Service Bulletin #208

February 14, 1966

SUBJECT: NEW LARGER - THICKER EXHAUST VALVES - A65 SERIES

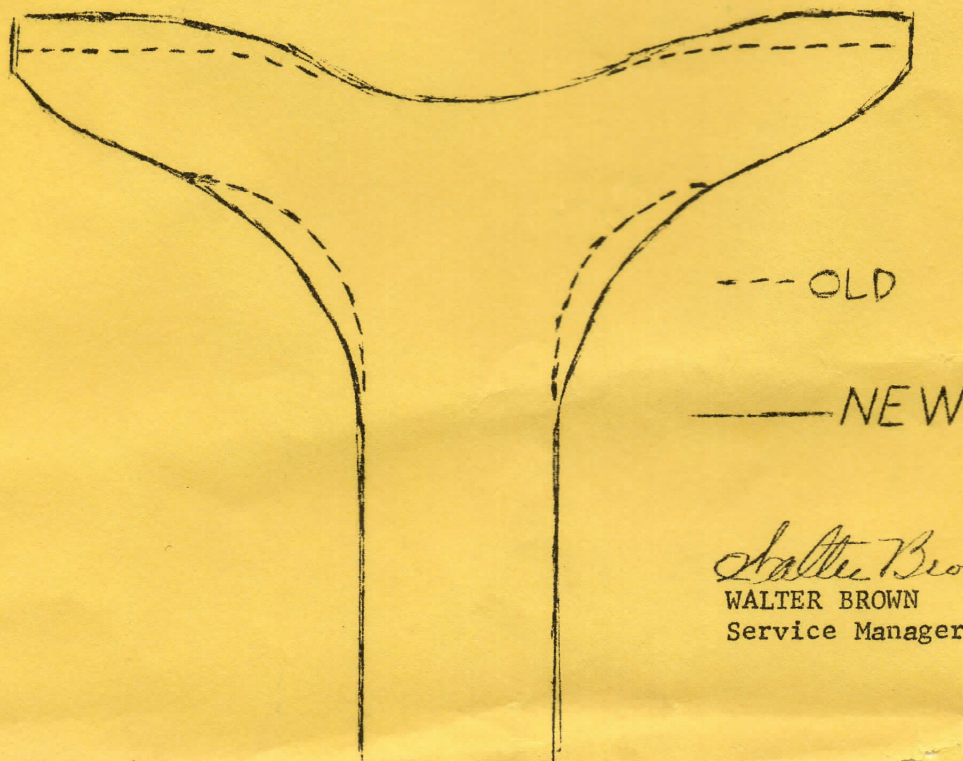
The 1966 EXHAUST Valve (new valve, 68-0663) has a much thicker head approximately .050) than any previous exhaust valve for the BSA A65 series motorcycles (old valve, 68-0157).

If you are using the new one as a replacement valve for any BSA A65 series built before 1966 - - it will be necessary to recess (cut deeper) the exhaust valve pocket in the top of the pistons ... or... you may install the new 1966 style piston (68-0784) which has the deeper pockets as standard.
